Access Compliance Report Public Rights-of-Way (Curb Ramps)

Intersection ID: 28391 Main Street: HIGHLANDS_CROSSING_DR Cross Street: ROYAL_HIGHLANDS_CT Location: E

ADA ID: 1EFA658A075E Ramp Type: Perp Initial Pass/Fail: Fail Overall Compliance: No Severity Score: 12.5

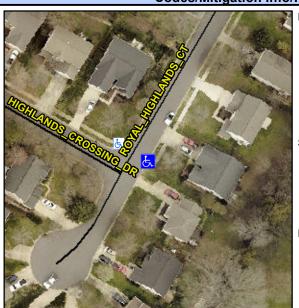
Possible Solutions:	Co		
Remove & Replace Entire Ramp.			
	Ye		
	N/		
Surveyor Notes:	N/		
N/A	N/		
	N/		
	N/		
	N/		
PROW/ADA:	N/		
Not Found, R304.5.3	N/		
	N/		
	N/
